ADDENDUM #1
INVITATION FOR BID #24-65

**NEWTON COMMONWEALTH GOLF COURSE MAINTENANCE FACILITY
IMPROVEMENTS AND RENOVATIONS**

Addendum to the Bidding Documents
Newton Commonwealth Golf Course
Maintenance Facility Improvements & Renovations

Addendum No. 1
April 19, 2024

1 ENLARGED GROUND FLOOR PLAN - EXISTING MAINTENANCE BUILDING
1/4" = 1'-0"

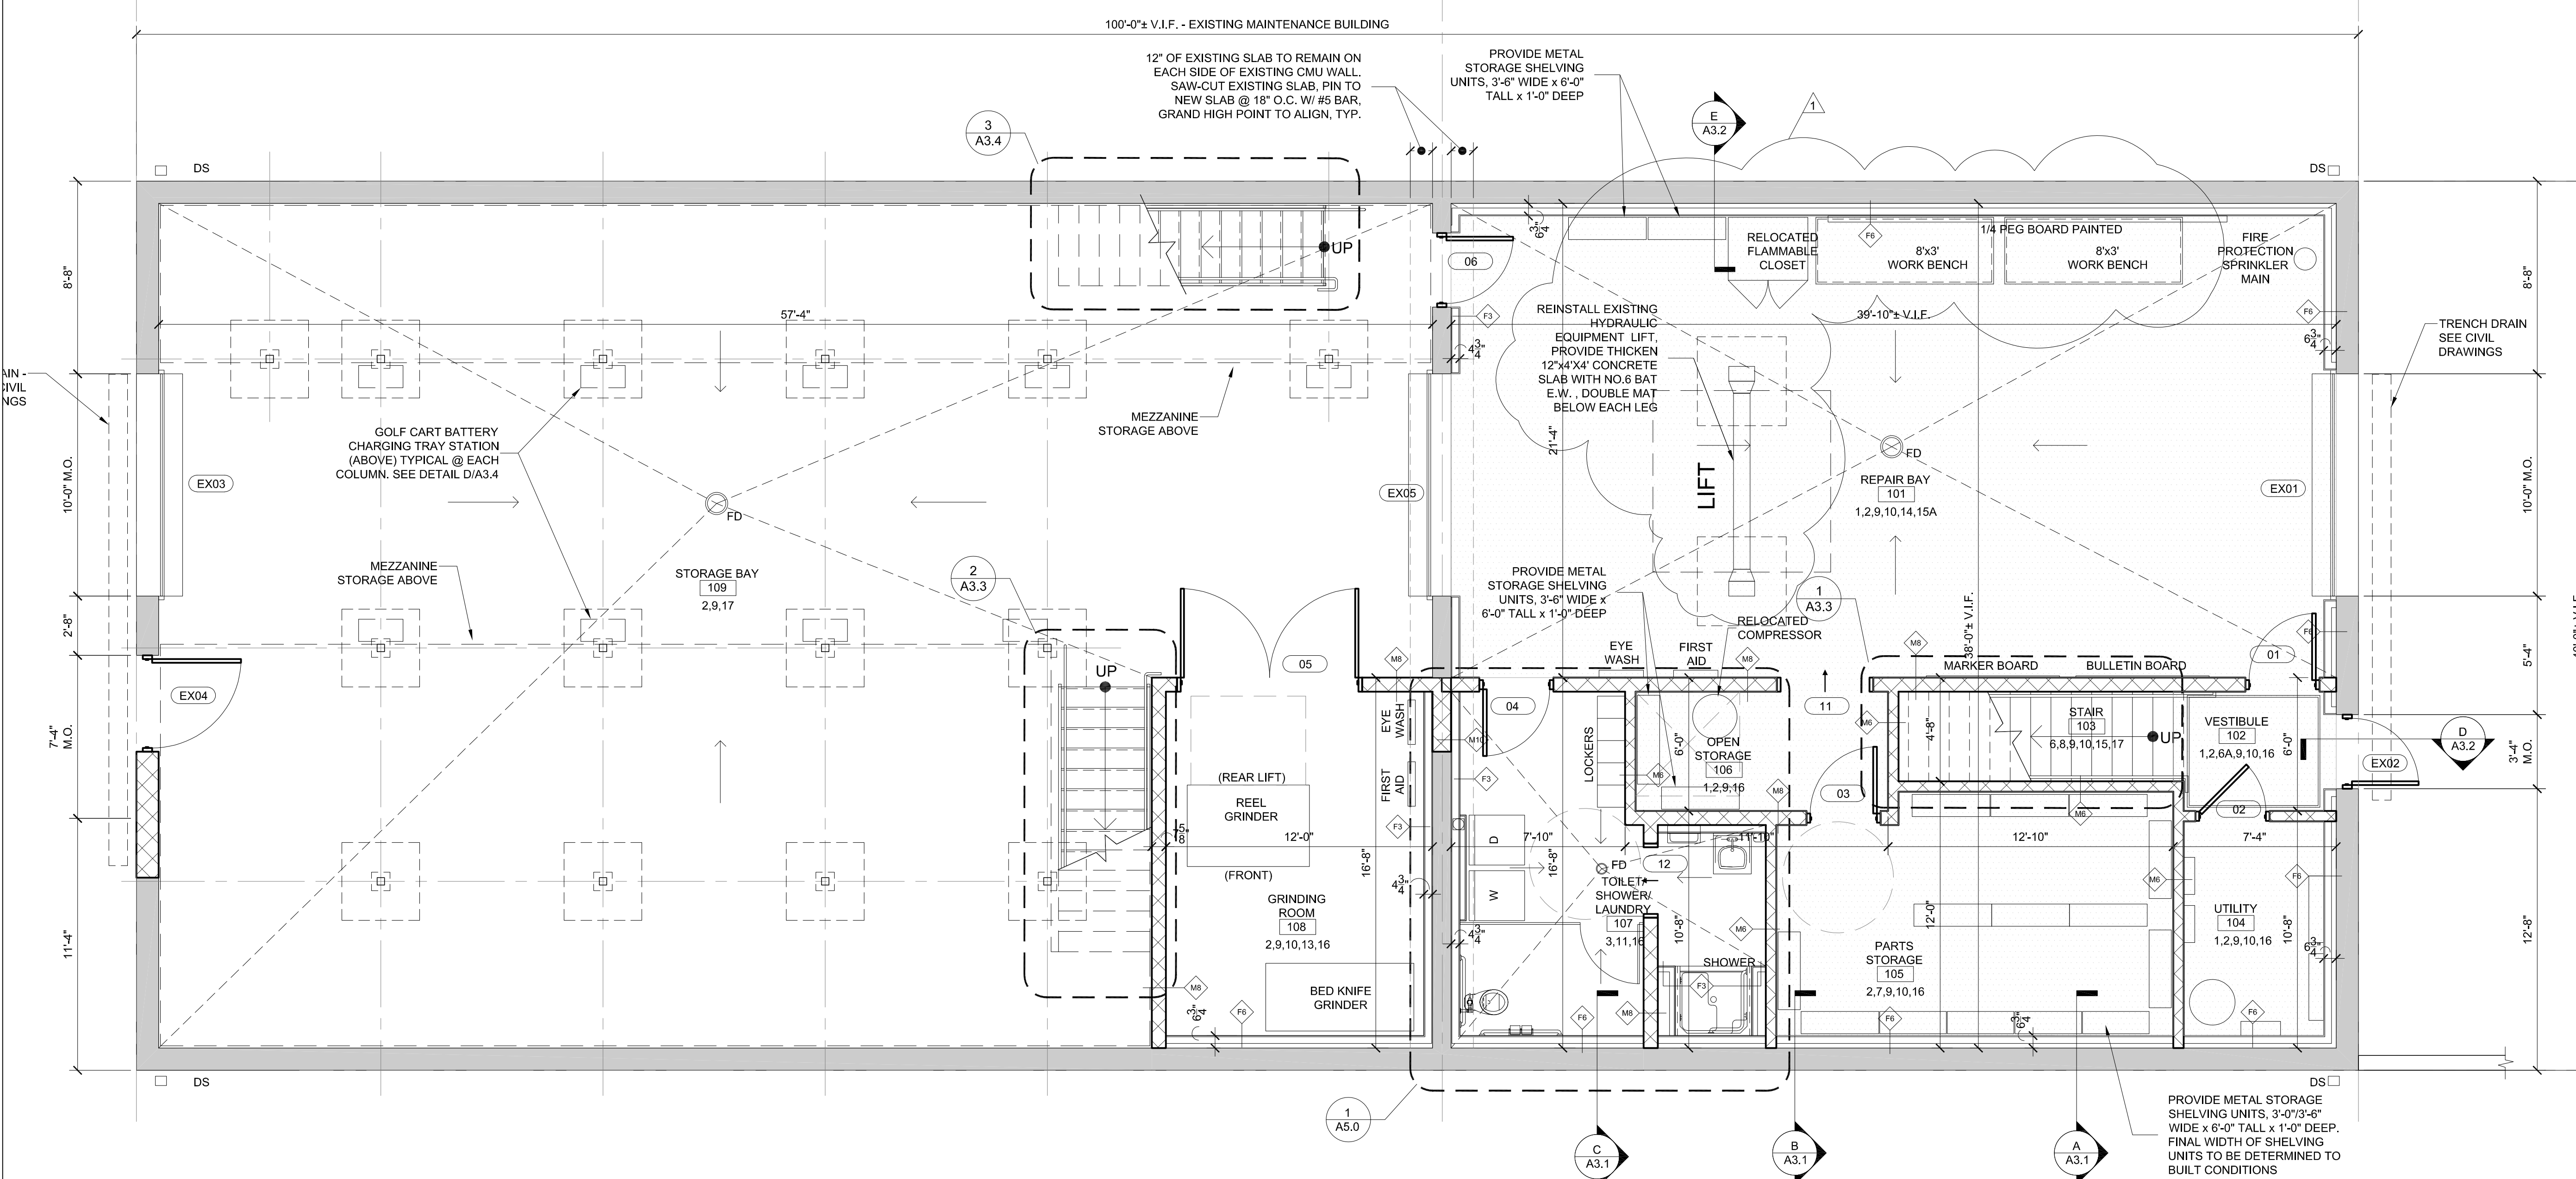
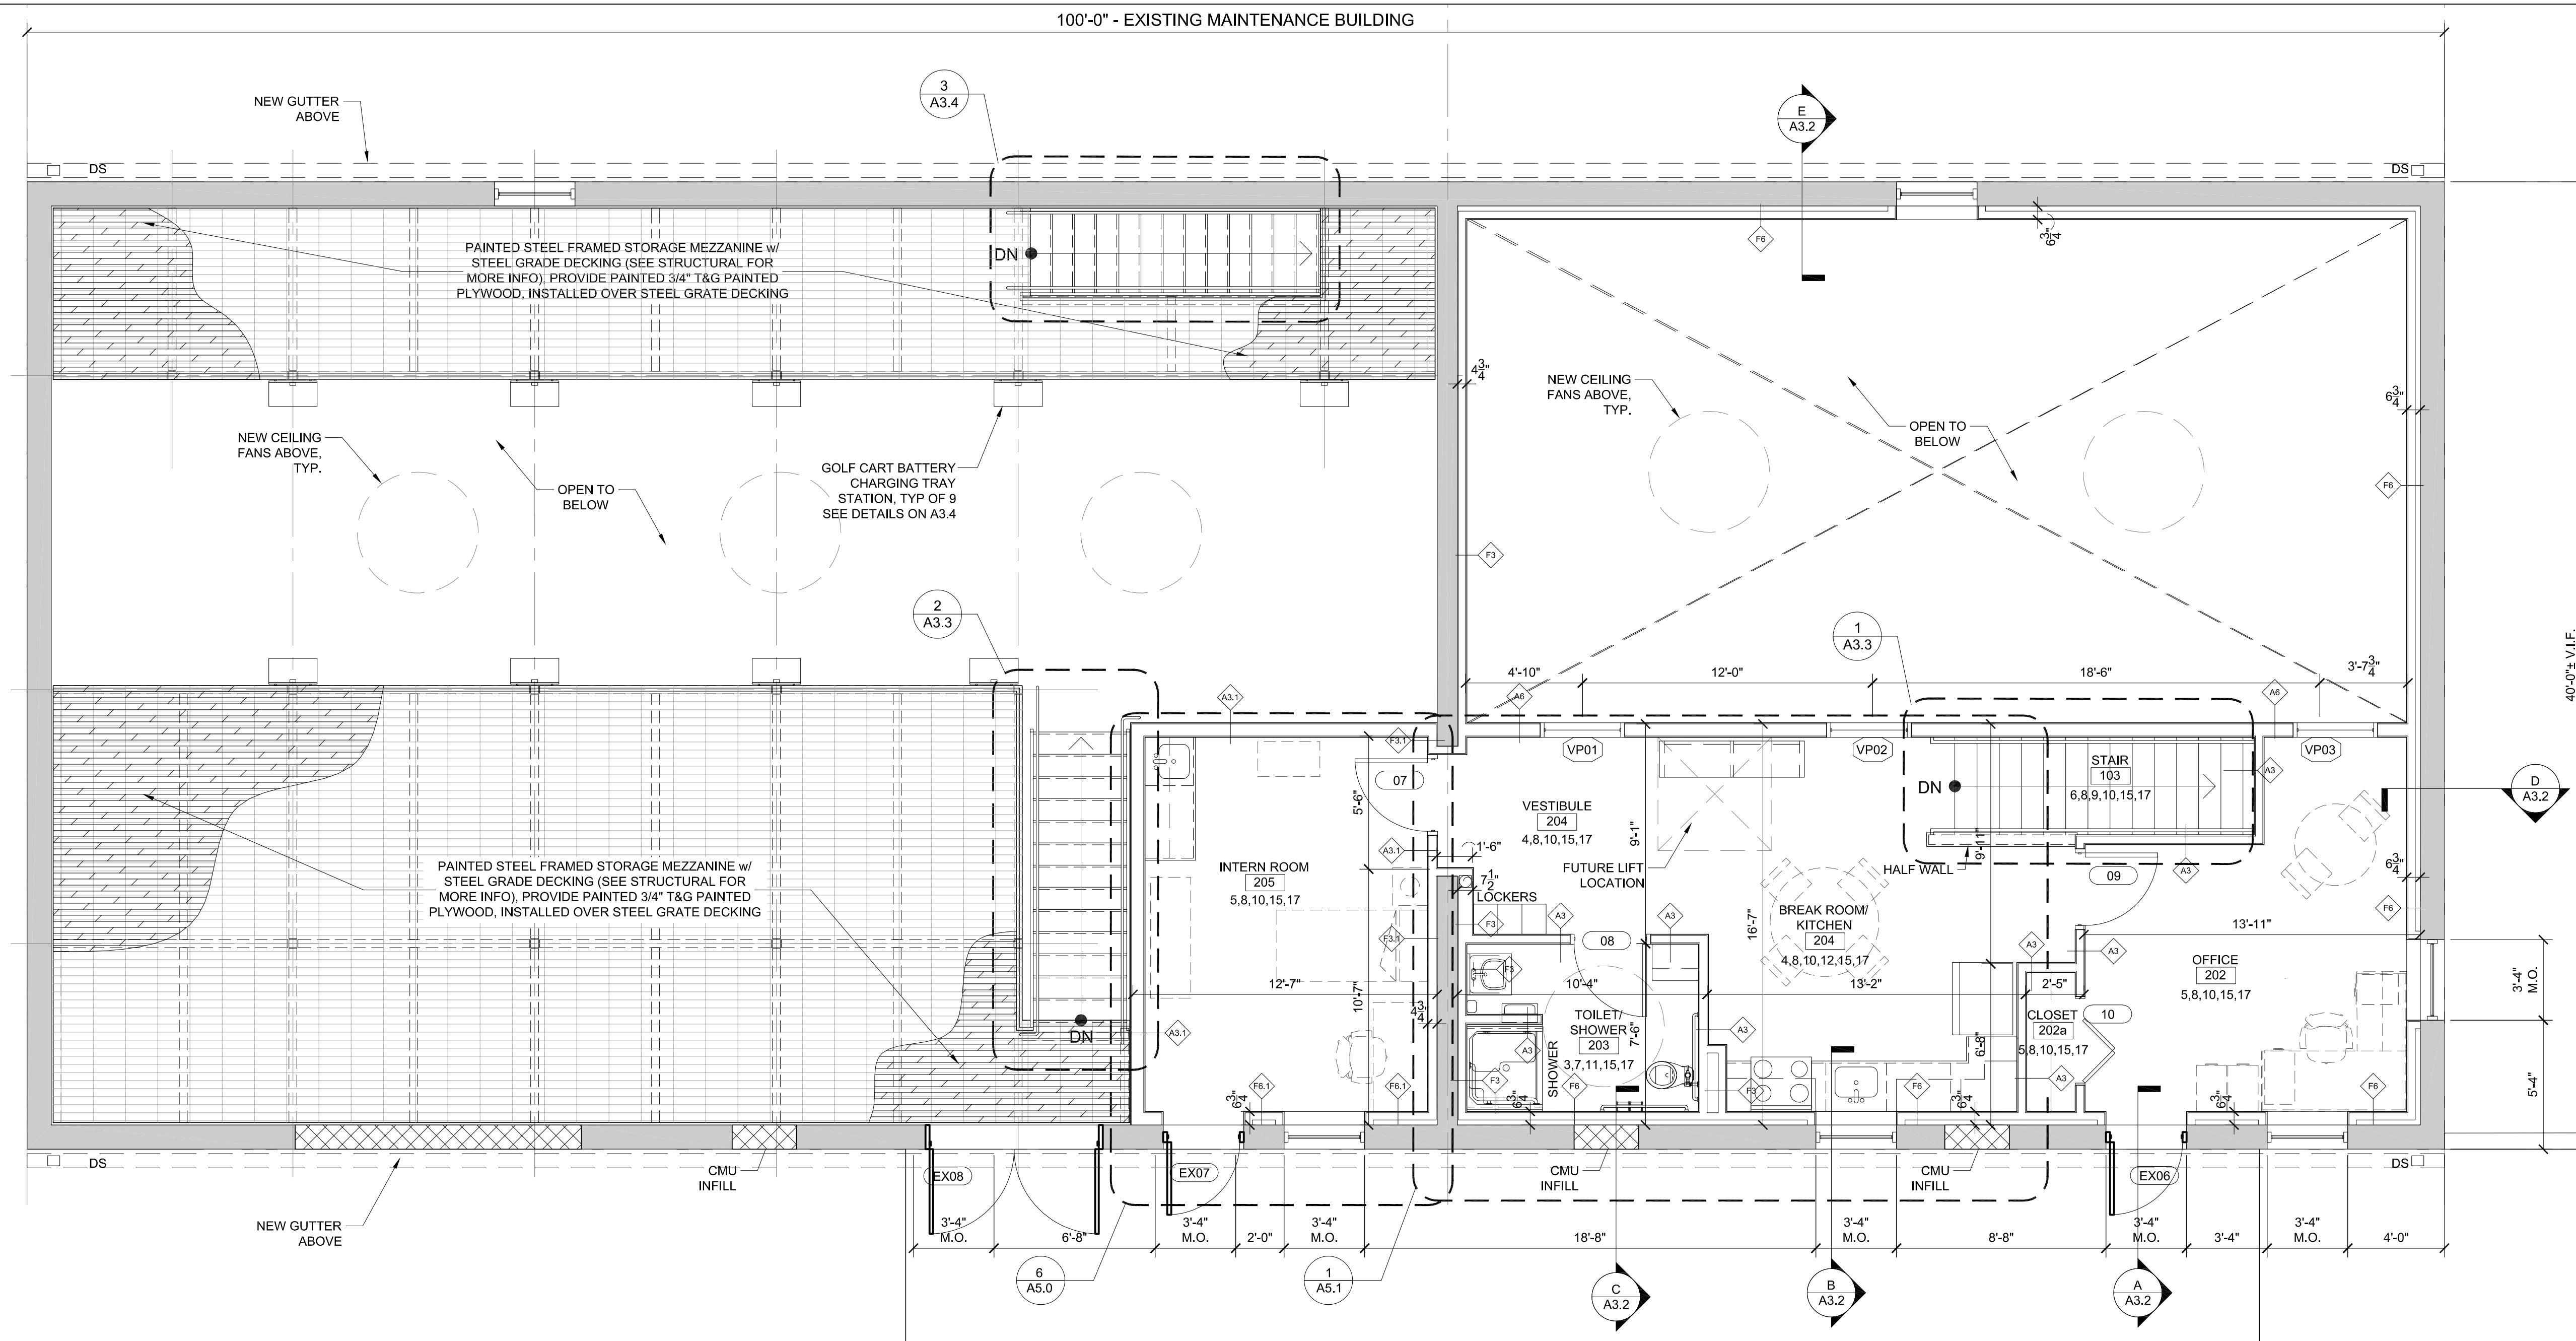
Q7. Page A1.1 Scope: Epoxy/Polished Concrete; A1.1 shows Repair Bay 101, Vestibule 102, Utility 104, and Open Storage 106 to receive both epoxy floor and sealed & polished concrete. Please clarify which flooring is required in these areas.

A7. Areas where epoxy floor coating is shown, provide troweled smooth finish concrete as per the epoxy floor manufacturers requirements for prep of surface.

1 SITE DEMOLITION & PREPARATION PLAN
C1.0 SCALE: 1" = 20'

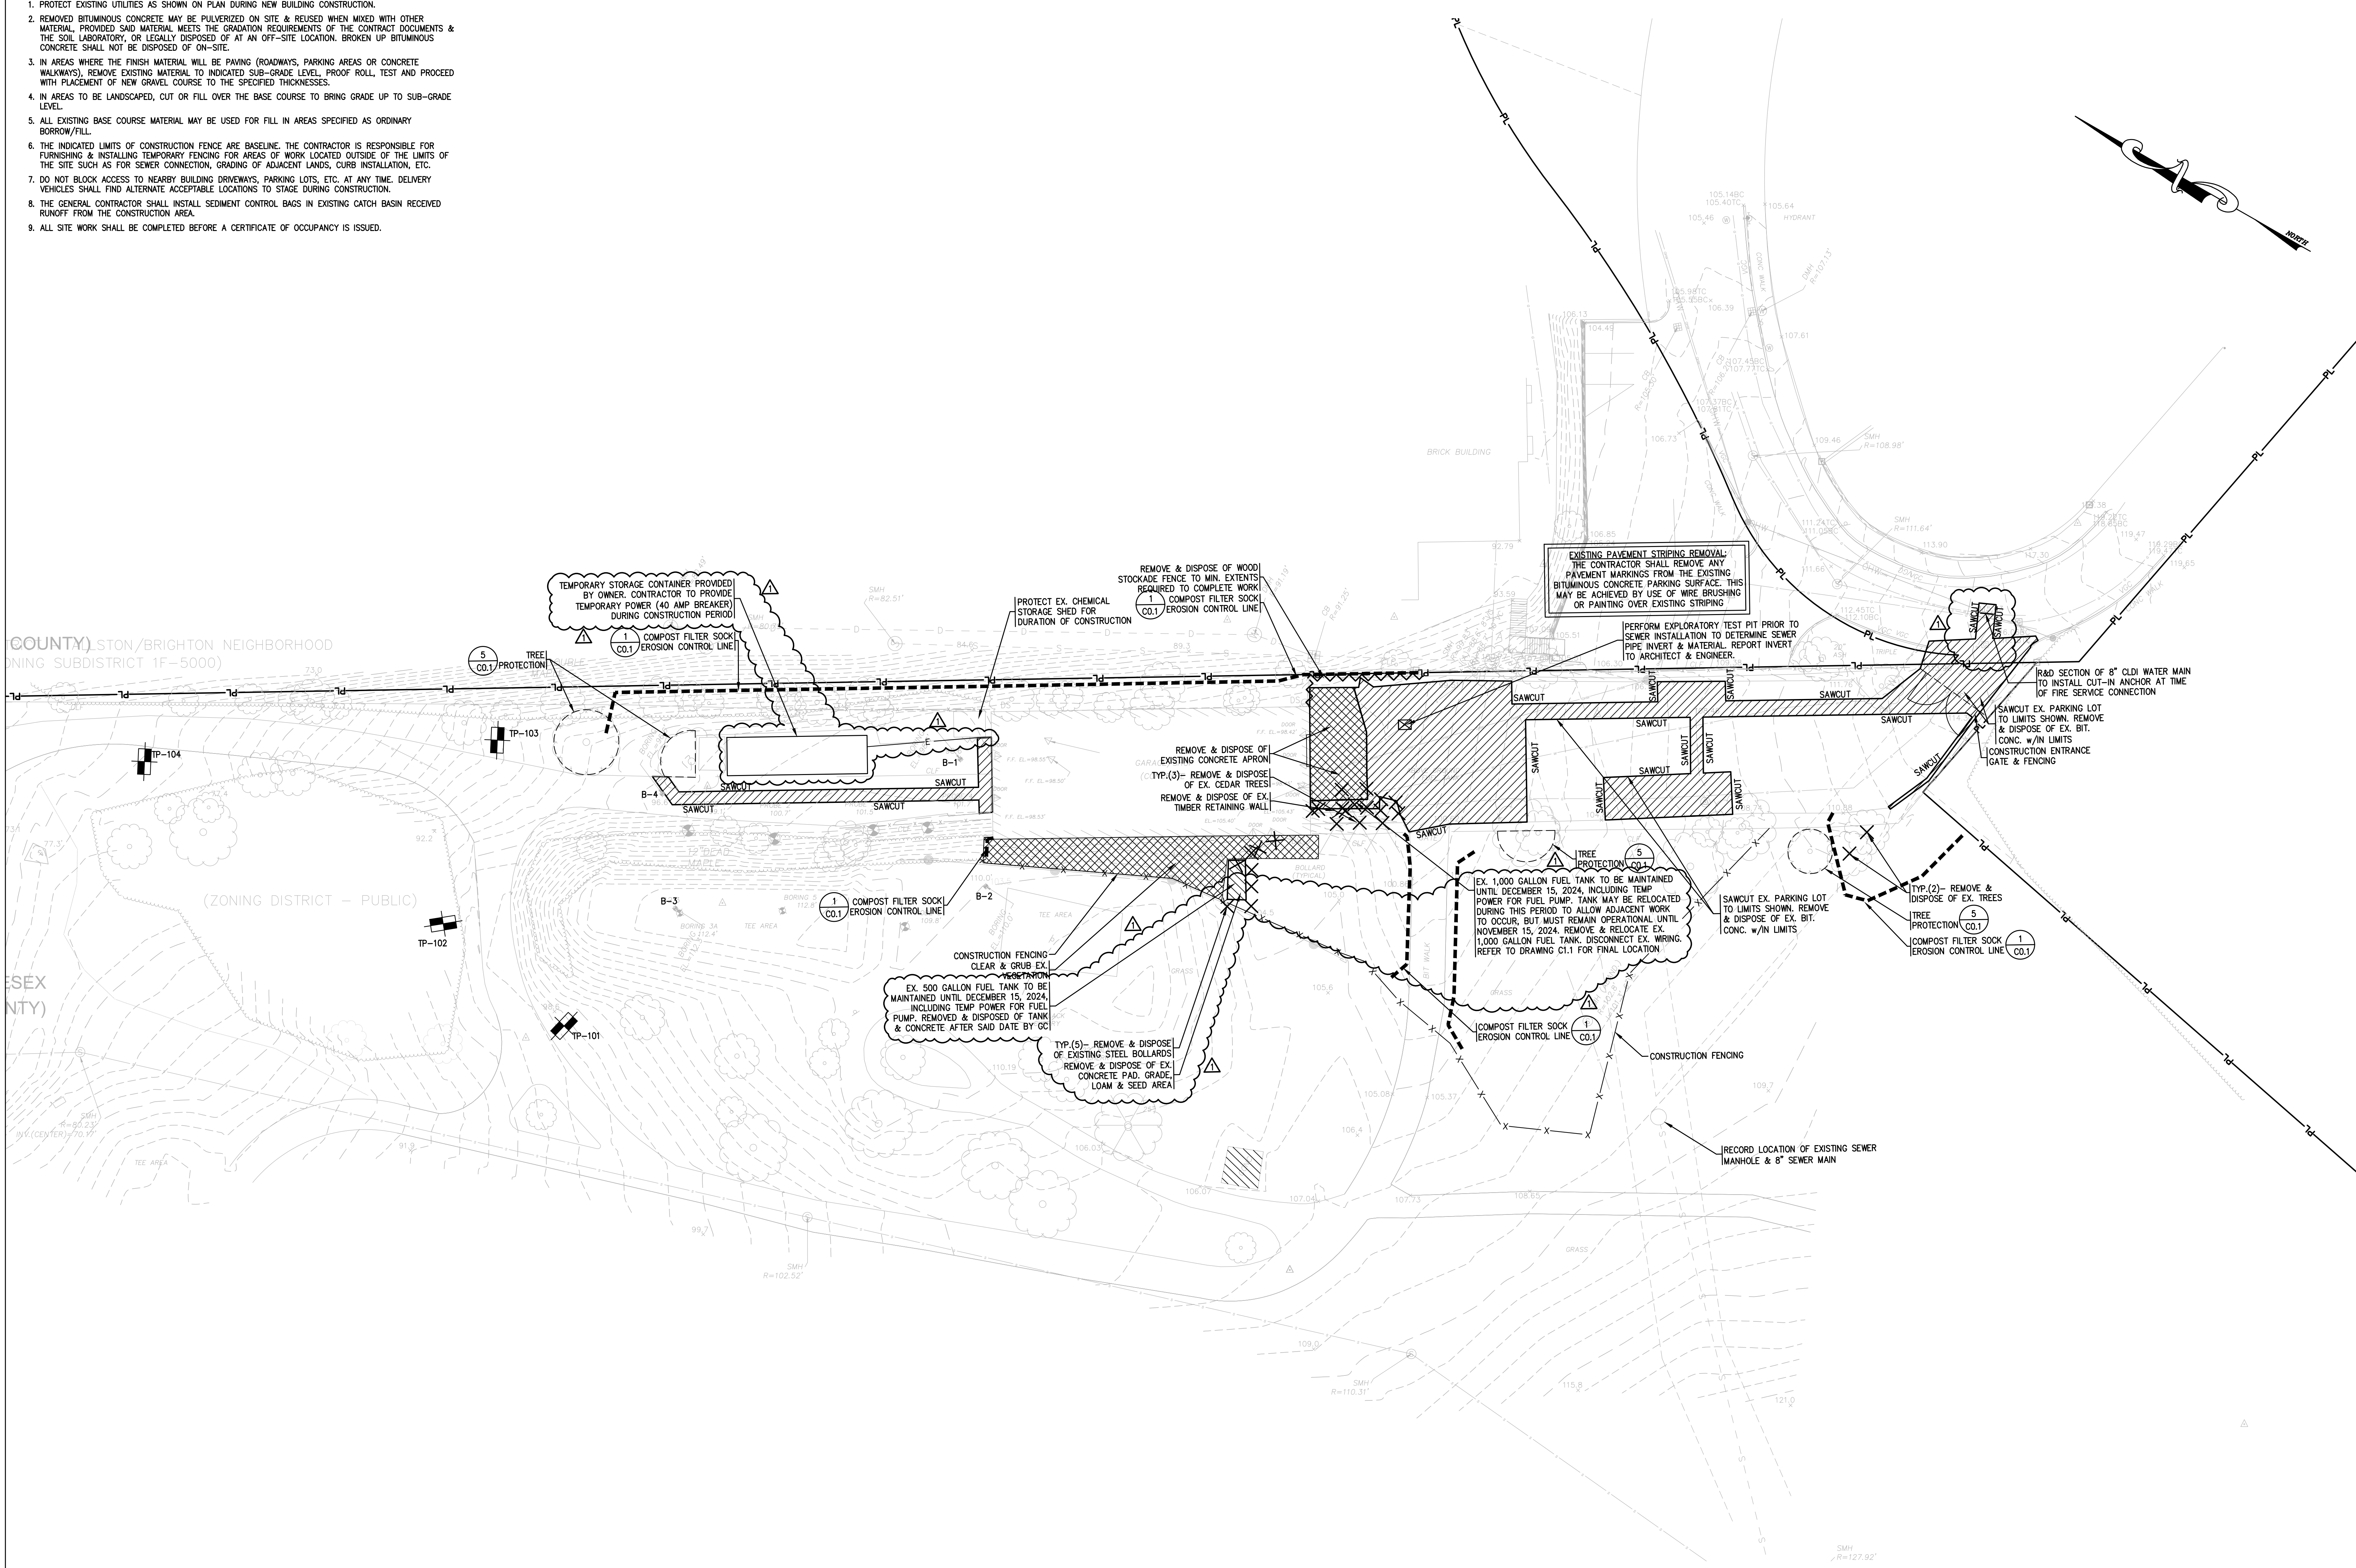
Q2. Page C1.0 Who is the Vendor to remove/reinstall existing 1,000 gallon gas tank?

A2. Meco Environmental Services, 1119 Washington Street, Weymouth MA 02189. The contractor is to own this work within the scope of the work of this project. The vendor identified in this response is who the contractor shall use to execute the work.
